SIB 61 23 20

RECALL 20V-601: HIGH-VOLTAGE BATTERY

This Service Information Bulletin (Revision 4) replaces SI B61 23 20 **dated December 2020**.

SP44 HV Battery (G05) modules

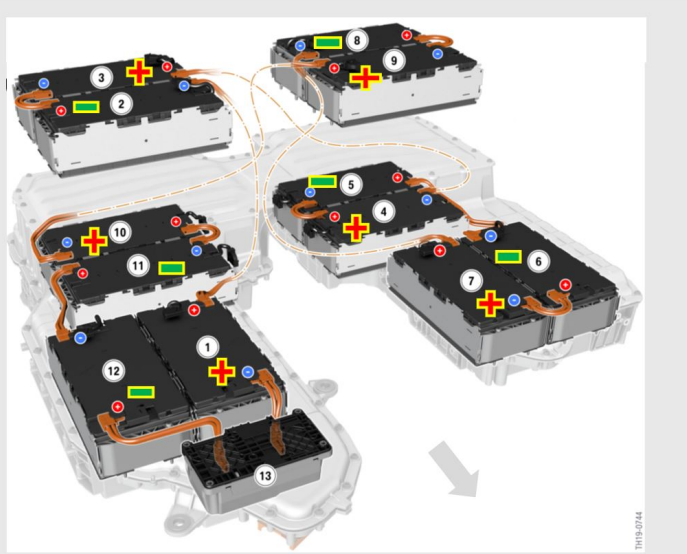
Modules are designed as Positive and Negative modules (with different orientation and part numbers). When replacing modules, verify in EPC the correct part (POS/NEG) and reinstall according to their original position. See below.

Use EPC diagram to verify the correct module part number (01/02) for NEG or POS modules.

Use the illustration on the right to match the part# with the correct module installation location.

- Module 12 is **NEG (01)**
- Module 1 is **POS (02)**
- Module 11 is **NEG (01)**
- Module 10 is **POS (02)**
- Module 2 is **NEG (01)**
- Module 3 is **POS (02)**
- Module 8 is **NEG (01)**
- Module 9 is **POS (02)**
- Module 5 is **NEG (01)**
- Module 4 is **POS (02)**
- Module 6 is **NEG (01)**
- Module 7 is **POS (02)**

SP41 HV Battery (G01/G20/G20/G12) modules

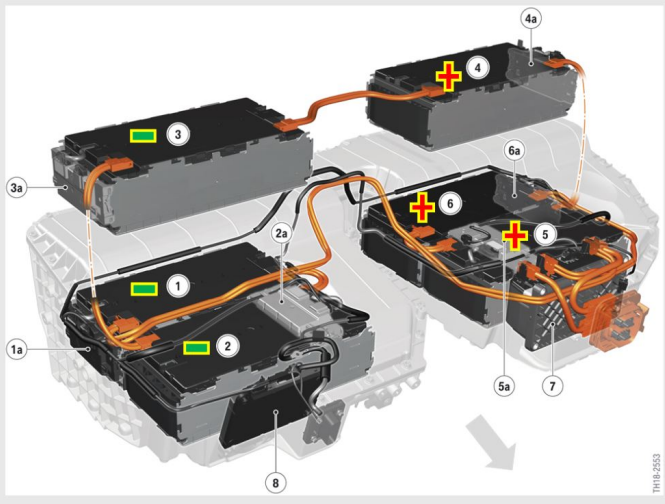
G01/G20/G30/G12 LCI modules (SP41 battery) are:**NEG (01) or POS (02)**

Use EPC diagram to verify the correct module part number (01/02) for NEG or POS modules.

Use the illustration on the right to match the part# with the correct module installation location.

- Module 1 is **NEG (01)**
- Module 2 is **NEG (01)**
- Module 3 is **NEG (01)**
- Module 4 is **POS (02)**
- Module 5 is **POS (02)**
- Module 6 is **POS (02)**
